Transport Note

Land to the North of Devizes Road, Trowbridge.

Date: August 2026 | Pegasus Ref: P22-0992 TR06

- 1.1. This Transport Note (TN) has been prepared by Pegasus Group on behalf of Redcliffe Homes Limited (the Applicant) in order to address issues raised by Wiltshire Council (WC) in its highways consultation response dated 12th June 2026 for planning application PL/2026/01072. The scheme is for up to 80 dwellings at land to the north of Devizes Road, Hilperton. It is understood that the highway authority has no objection in principle to the scheme.
- 1.2. The access arrangements are similar to those proposed for previous planning application PL/2022/07977 on the site, to which WC as the highway authority raised no objection subject to conditions and contributions.
- 1.3. The key issues raised by WC in its consultation response dated 12th June 2026 are summarised below and then addressed in turn.

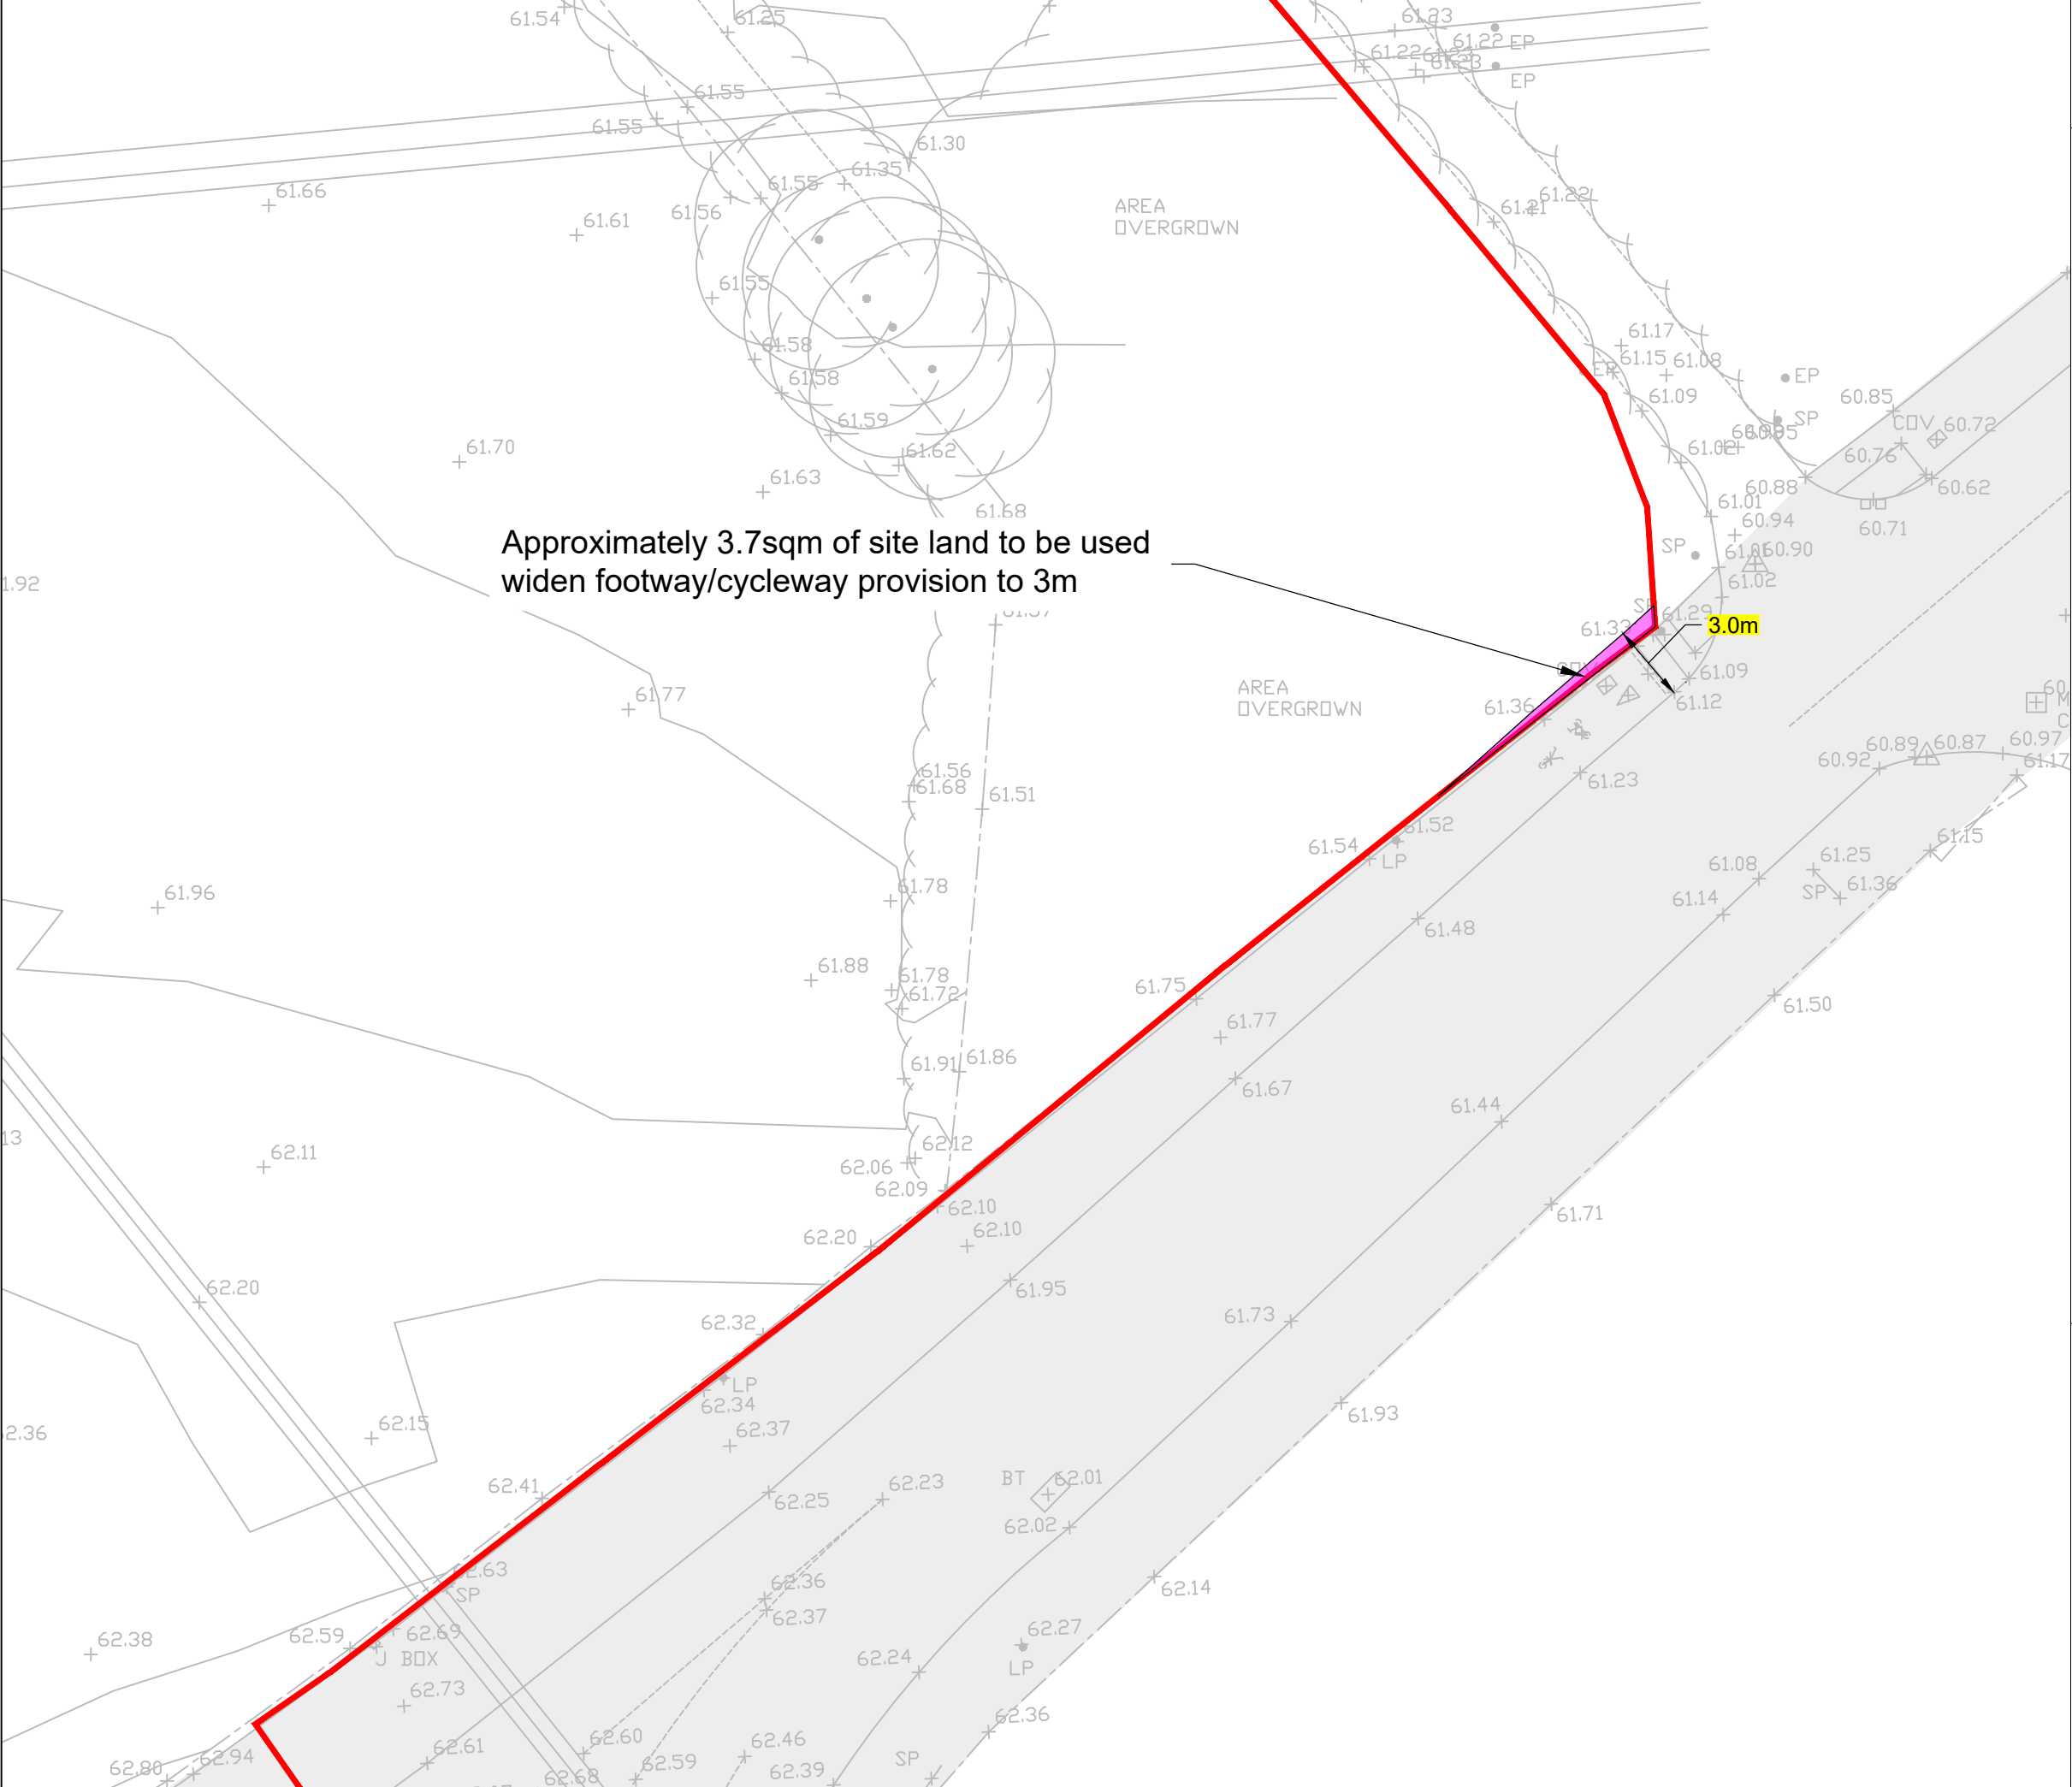
- 2.3. WC has also requested that the existing footway/cycleway provision to the east of the site is widened to three metres on the west side of the junction with PRow HILP21 using land within the site.

- 2.6. This requested widening works to the footway/cycleway along the site's frontage has been accommodated in the updated site plans and is also shown in drawing P22-0991 SK/14, included at **Appendix A**.

DRAWING NUMBER:
P22-0991_SK13

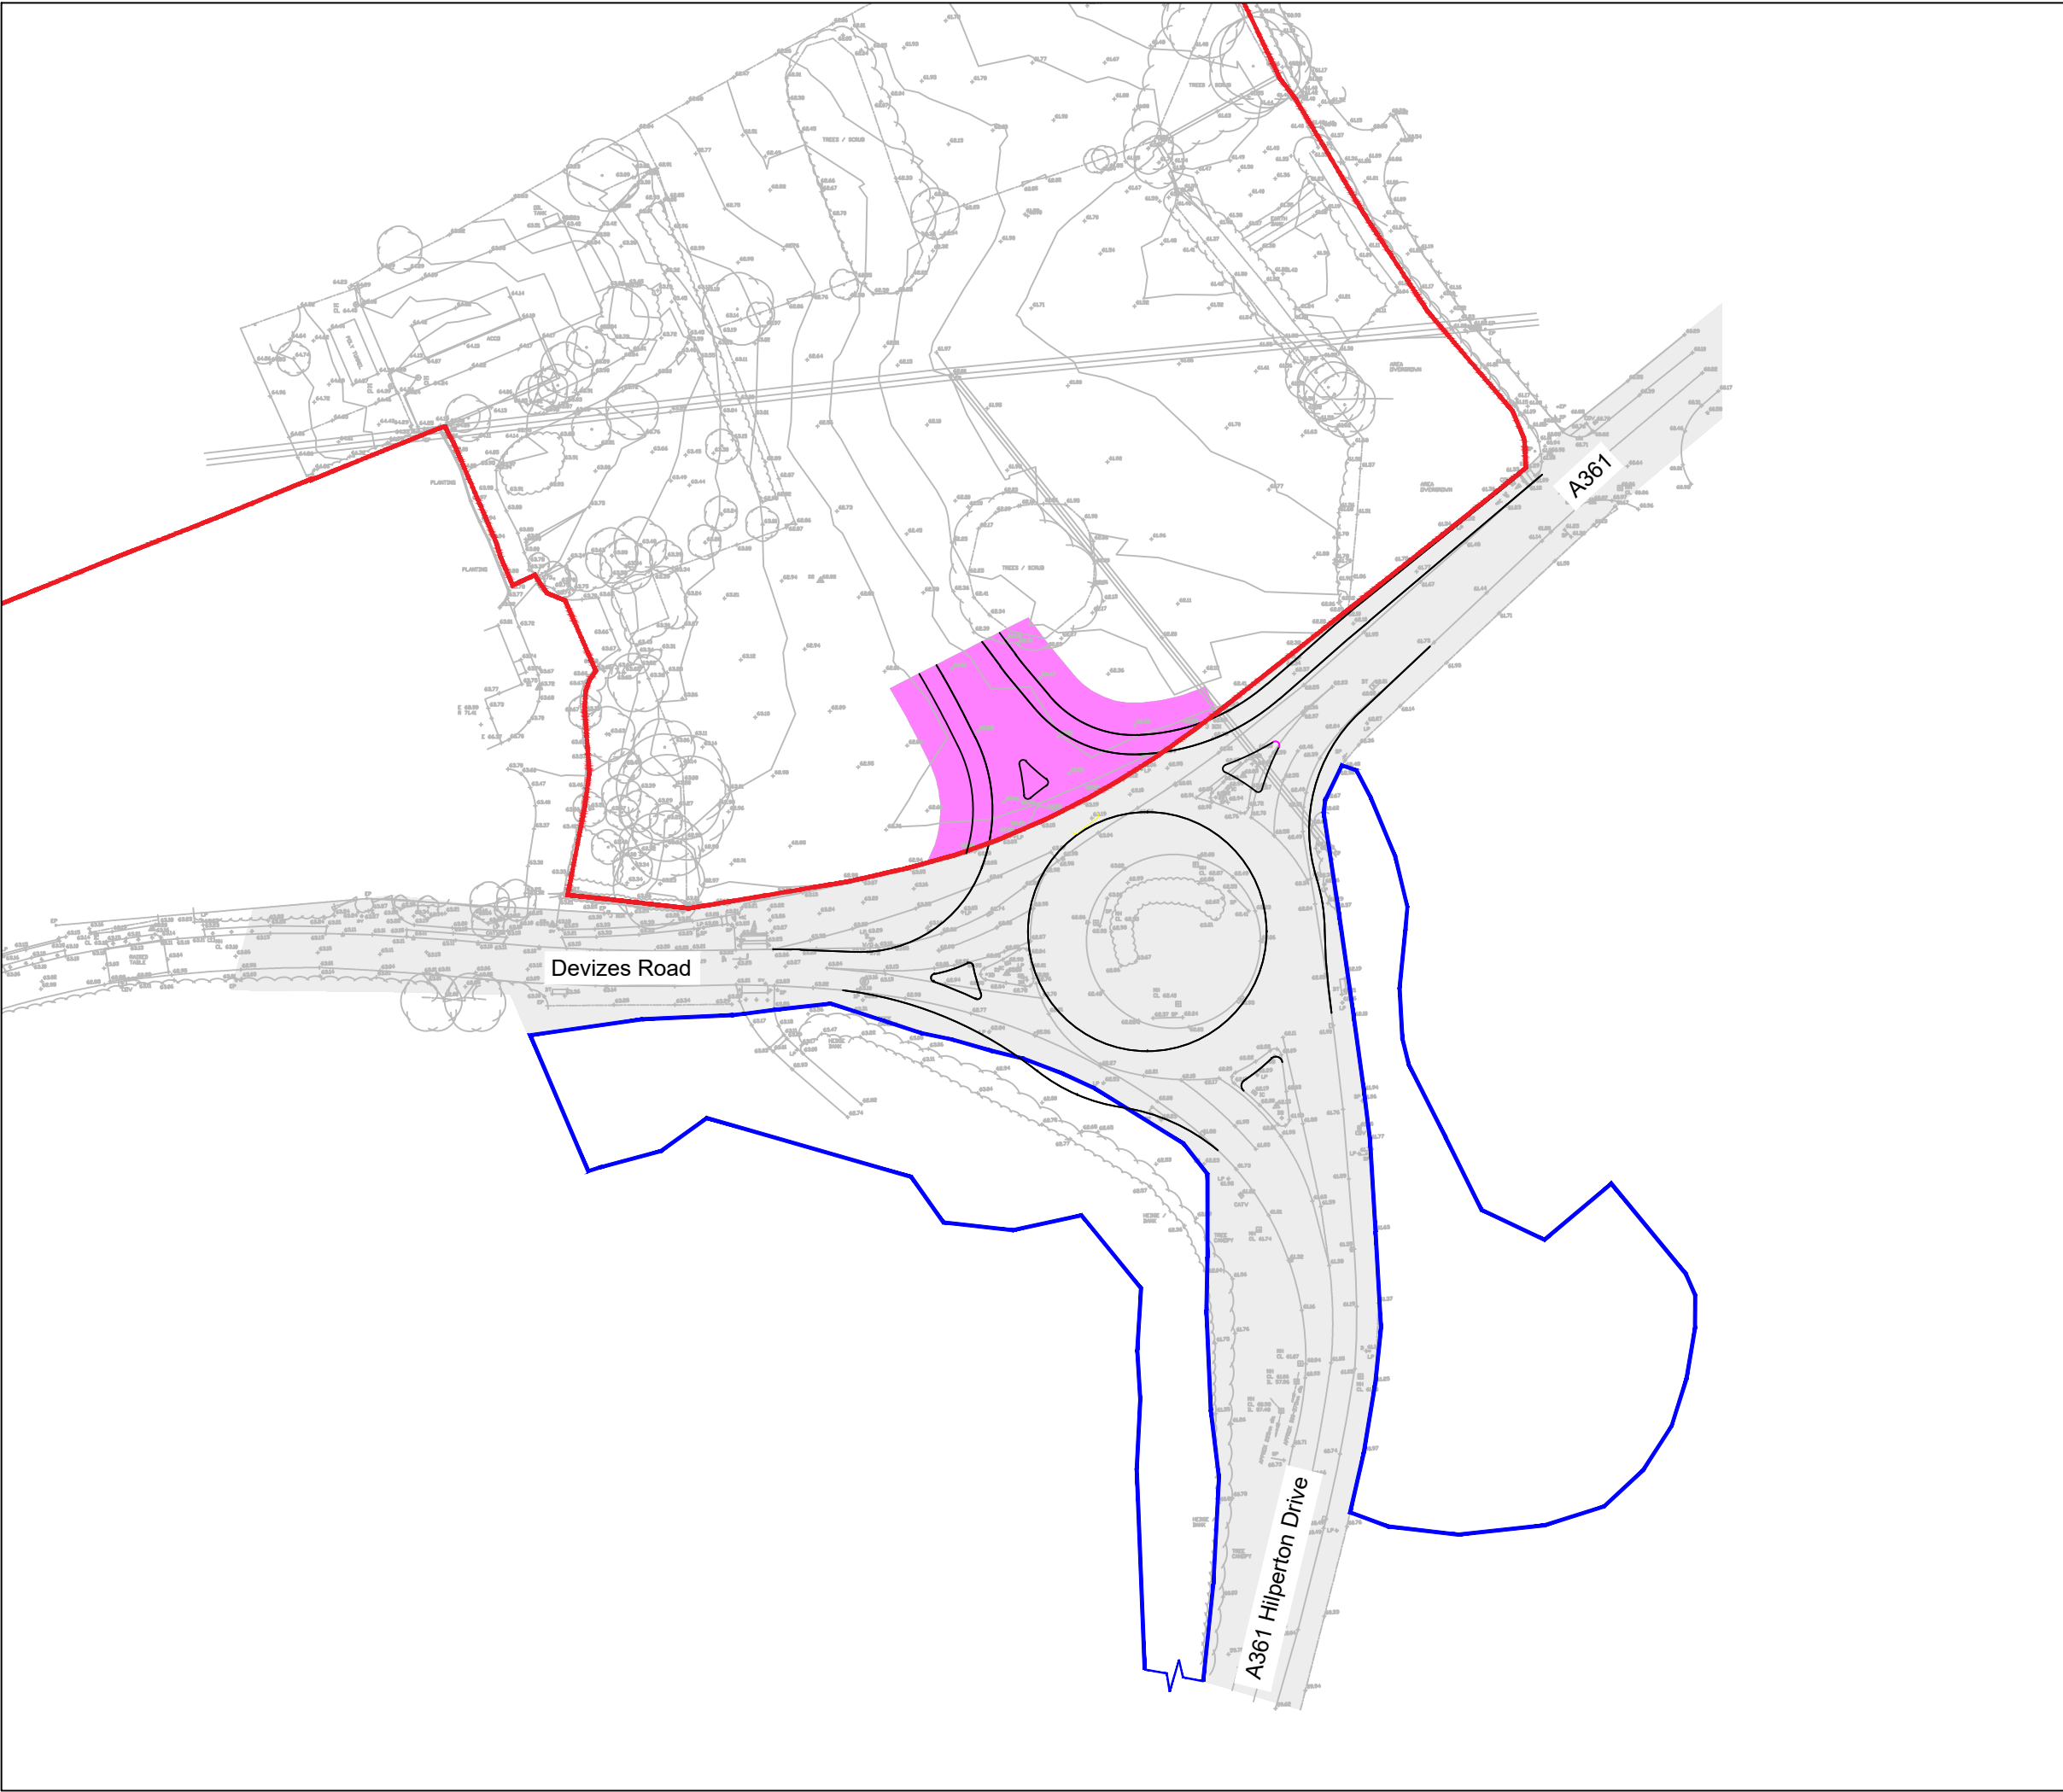
- 2.16. A drawing showing the land that will be allocated for indicative future roundabout access design (shown in Appendix E of the TA) is requested to be provided.
- 2.17. It is also noted that the Concept Masterplan drawing differs in terms of the location of where dwellings are set out with the indicative future access design at Appendix E of the TA and it is requested that the position relating to this is confirmed.

- 2.18. A drawing showing the land to be allocated for the future roundabout design as shown in Appendix E of the TA has been prepared and is included at drawing P22-O991 SK/13, included at **Appendix D**.
- 2.19. The updated masterplan included as part of the wider package of updated information addresses the location of where dwellings are set out with regard to the indicative future access design. The location of dwellings has been amended in accordance with the future access design. It is also noted that the final layout design is a Reserved Matter.
